UNITED STATES PATENT AND TRADEMARK OFFICE

APPLICATION NO.	FILING DATE	FIRST NAMED INVENTOR	ATTORNEY DOCKET NO.	CONFIRMATION NO.
10/564,882	06/30/2006	Hanno Tautz	LINDE-0637	3893
23599 7590 11/20/2008 MILLEN, WHITE, ZELANO & BRANIGAN, P.C. 2200 CLARENDON BLVD. SUITE 1400 ARLINGTON, VA 22201				
EXAMINER				
PEREIRO, JORGE ANDRES				
ART UNIT		PAPER NUMBER		
3743				
MAIL DATE		DELIVERY MODE		
11/20/2008		PAPER

Office Action Summary

DETAILED ACTION

Fig. 1

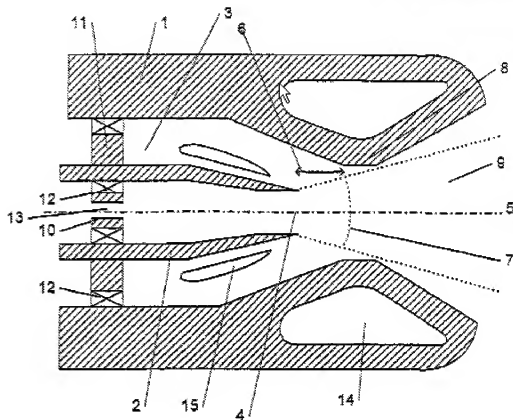
3. Claims 1, 5-12 and 15-24 are rejected under 35 U.S.C. 103(a) as being unpatentable over WO 02/42686 A1 to Ranke et al. ("Ranke").
4. In re Claim 1, with reference to figure 1 below, Ranke discloses a combustible gas burner comprising a burner head (1) and inner (2) and outer (3) coaxial gas supply channels for the combustible gas and for a gas containing oxygen that are located in the burner head.

5. However, Ranke does not disclose the channel for oxygen containing gas having a cross sectional area of 0.8 to 1.8 times the cross sectional area of the channel for combustible gas, and wherein the burner head, at least in the area of coaxial exit ends of the coaxial gas supply channels, consists essentially of steel optionally alloyed with aluminum as a base, said base being coated with aluminum.

8. In re Claim 5, with reference to figure 1 above, Ranke discloses all of the claim limitations including wherein at least one of the gas supply channels (3), comprises a vane (15) therein that stabilizes gas flow.

9. In re Claim 6, with reference to figure 1 above, Ranke discloses all of the claim limitations including wherein the vane (15) is set back relative to the exit ends (4, 6) of the coaxial gas supply channels (2, 3).

12. In re Claim 8, with reference to figure 1 above, Ranke discloses all of the claim limitations including wherein supply channels for the combustible gas (3) and the gas containing oxygen (2) are inner and outer tubes arranged coaxially to one another.

13. In re Claim 9, with reference to figure 1 above, Ranke discloses all of the claim limitations including comprising means (10, 11) for producing a swirl flow in the gas supply channels.

14. In re Claims 10 and 22, with reference to figure 1 above, Ranke discloses all of the claim limitations including wherein the means for producing a swirl (10, 11) comprise flow channels tilted tangentially against the direction of flow (*see* pg. 11, second paragraph).

15. In re Claim 11, with reference to figure 1 above, Ranke discloses all of the claim limitations including wherein the means for producing a swirl (10, 11) in the gas supply channels are adjustable in order to produce swirl flows of varied intensity (*see* pg. 7, third paragraph).

16. In re Claim 12, with reference to figure 1 above, Ranke discloses all of the claim limitations including wherein in the outside area, the burner (1) has means (14) for cooling by a vapor flow.

19. In re Claims 17 and 18, with reference to figure 1 above, Ranke discloses all of the claim limitations including said outer channel (3) having an exit end (6) inclined toward the inner channel (2).

20. In re Claims 19-21, with reference to figure 1 above, Ranke discloses all of the claim limitations including comprising means (10, 11) for producing a swirl flow in the gas supply channels.
